102-07986-MLL/MDD
October 4, 2019

Subject: **Palo Verde Nuclear Generating Station (PVNGS) Units 1, 2, and 3
Docket Nos. STN 50-528, 50-529, and 50-530
Renewed Operating License Nos. NPF-41, NPF-51, and NPF-74
Response to NRC Request for Additional Information Regarding License
Amendment and Exemption Requests Related to the Implementation of
Framatome CE16HTP Fuel**

**Response to NRC Staff Request for Additional Information
Regarding License Amendment and Exemption Requests
Related to the Implementation of
Framatome CE16HTP Fuel**

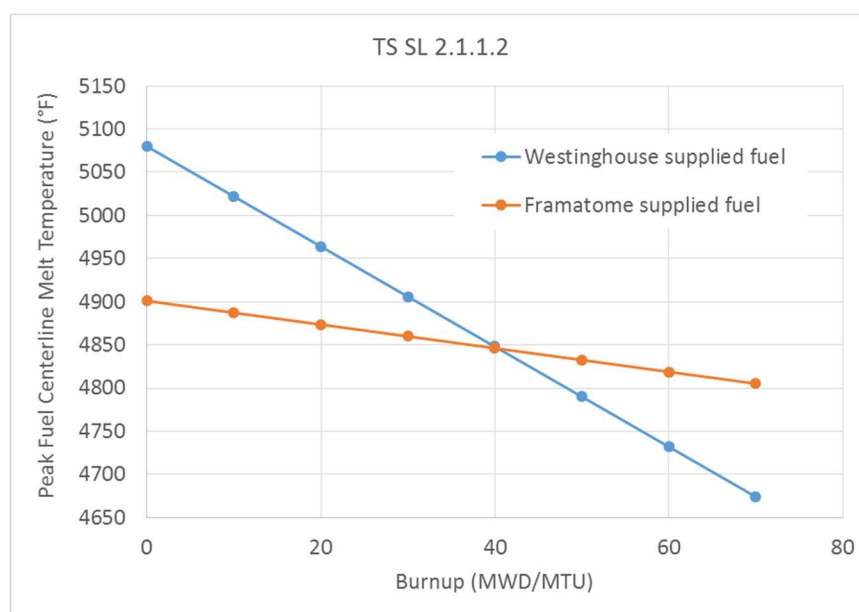
For multiple transients, the LAR dated July 6, 2018, states that “The maximum LHGR [linear heat generation rate] will remain below the value that causes peak centerline melt temperature (TS 2.1.1.2 limit).”

However, the TS 2.1.1.2 limit is provided in terms of peak fuel centerline temperature. Further, there are separate limits for Westinghouse Supplied Fuel and for Framatome Supplied Fuel, which vary as a function of burnup as plotted below.

Table 2-3 of Attachment 10 of the LAR dated July 6, 2018, indicates that **[[** **]]**. Additional information is needed to demonstrate how LHGR values are controlled to ensure that peak centerline melt is precluded and that variations in fuel type and **[[** **]]** are accounted for in the calculations for UFSAR events 15.4.2 and 15.4.3.

Figure 4-1: Steam Generators and Turbine Control Valve Mass Flow Rates

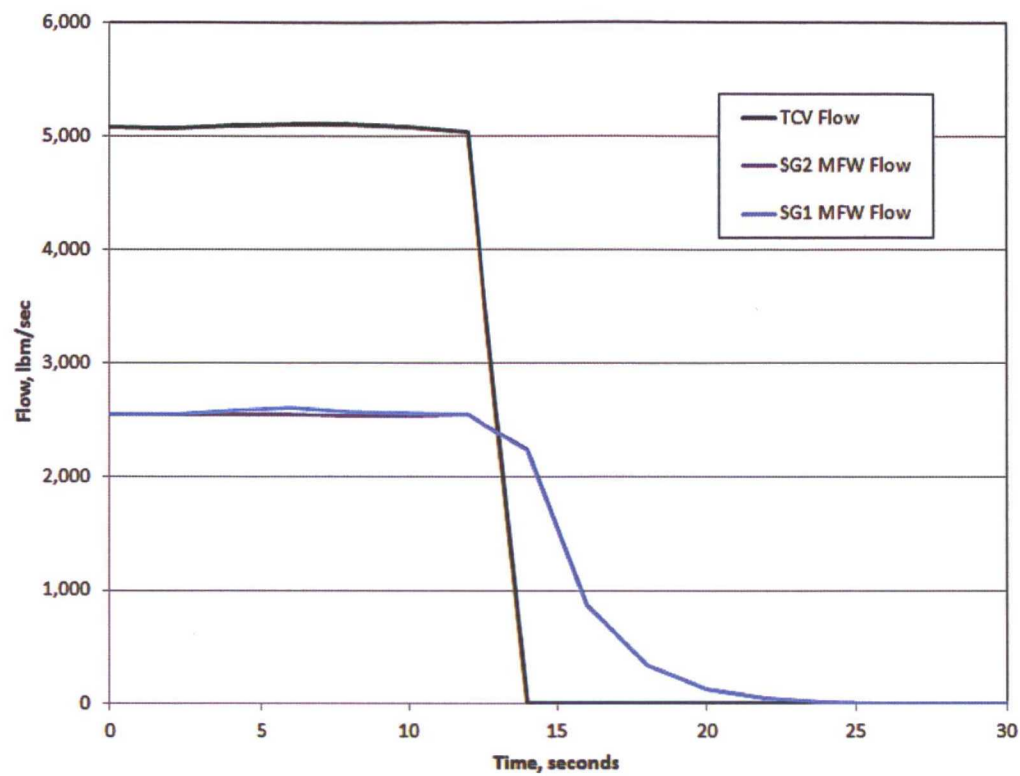
- (a) Prior to 200 seconds into the event, the steam generator total mass in Figure 4-14, "Steam Generator Total Mass – 9.10 Inch Break," of ANP-3640P begins to vary as a function of time, despite Figures 4-11 (main feedwater flow), 4-12 (steam generator safety valve mass flow) and 4-13 (auxiliary feedwater flow) showing no appreciable changes in the mass flow into or out of the steam generators.*

The mass plots shown in Figure 4-14 of ANP-3640P are the total mass for each Steam Generator (SG) vessel (ANP-3640P, Figure 3-3: []) on the secondary side and do not reflect any mass from the remaining secondary system components (i.e., steam lines and steam line components). Small changes in SG mass are expected from steam redistribution across the secondary path as a result of SGs response to key events during the transient. The overall significance of the mass

variations over time is relatively small, but appears to be more significant due to the scaling in the y-axis (4%). Variations on key points along the SG mass plots prior to 200 seconds in Figure 4-14 are explained below with respect to key transient events.

Prior to 200 seconds, there is a second mass change in the SGs which coincides with the start of the SIT injection (169 seconds) in the RCS. At this point the MSIVs are still open, allowing steam flow between the two SGs to maintain equal pressures. Consequently, the steam mass will redistribute in the secondary path in response to changes in the primary such as ECCS cooling. This explains the mass diversion between the two SGs observed bit prior to 200 seconds in Figure 4-14 of ANP-3640P.

As demonstrated in the discussions above, the total secondary mass is preserved through the transient and the SGs mass variations observed in the plots of ANP-3640P are the result of expected steam generator response. Therefore, the predicted behavior in the secondary is physical and reasonable.

**Figure 4-3: Core Exit and Upper Plenum Void Fractions**

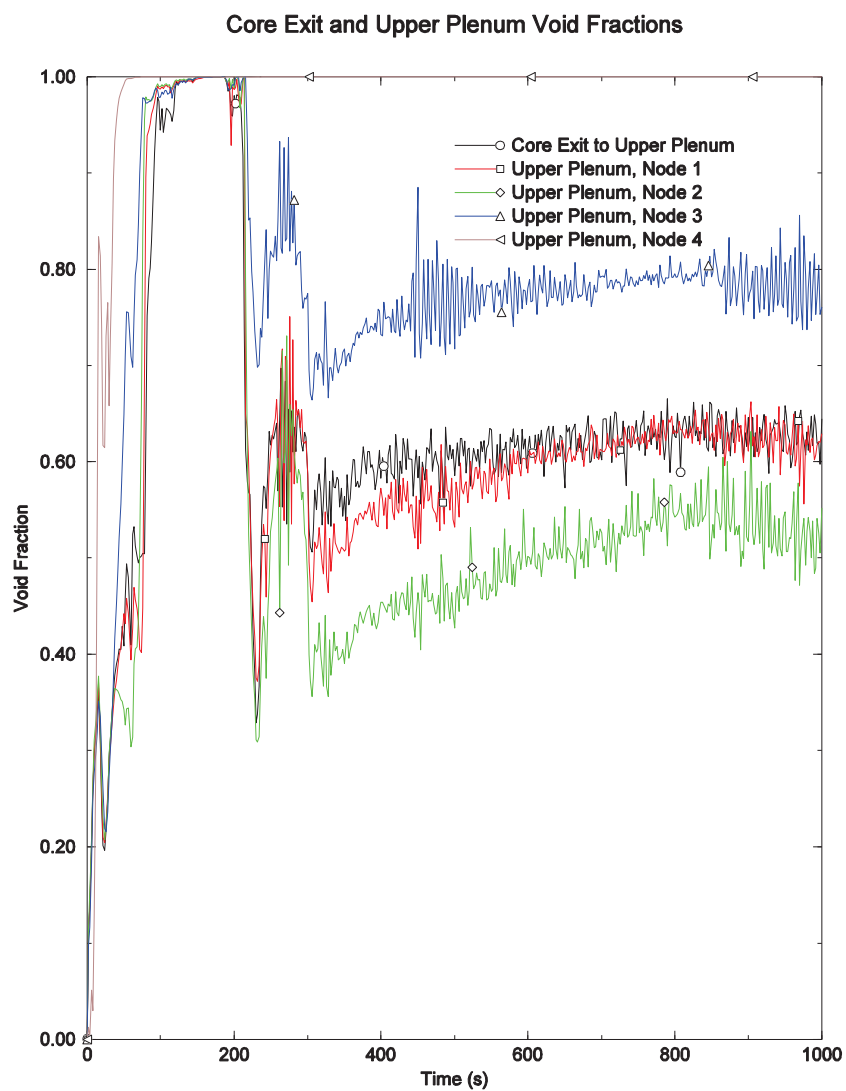
- (b) After about 200 seconds into the event, the hot assembly mixture level in Figure 4-22, "Hot Assembly Mixture Level – 9.10 inch Break," of ANP-3640P appears to take several different, approximately constant, values across several different periods, most prominently between approximately 355 and 620 seconds; whereas it is not obvious why the hot assembly mixture level should remain approximately constant during this period at a number of distinct values, all of which are below the top of active fuel.*

Figure 4-22 of ANP-3640P shows a plot of the "Hot Assembly Mixture Level." [

can be misleading, particularly after the core begins to refill and PCT has occurred (approximately 200 seconds for this break size, Figure 4-23 of ANP-3640P).

During an SBLOCA, with the exception of the accumulator injection, the core is essentially a boiling pot with the void fraction profile increasing with elevation above the bottom of the core. Consequently, there is no sharp delineation between the liquid region and steam region in the core. [

] Instead, a plot of void fraction in the core exit and upper plenum provides a much clearer demonstration of the reactor vessel mixture level. Figure 4-3 demonstrates that the mixture level is above the top of the active fuel and that the mixture level is stable following the redistribution of inventory in the reactor vessel after the rapid accumulator surge.
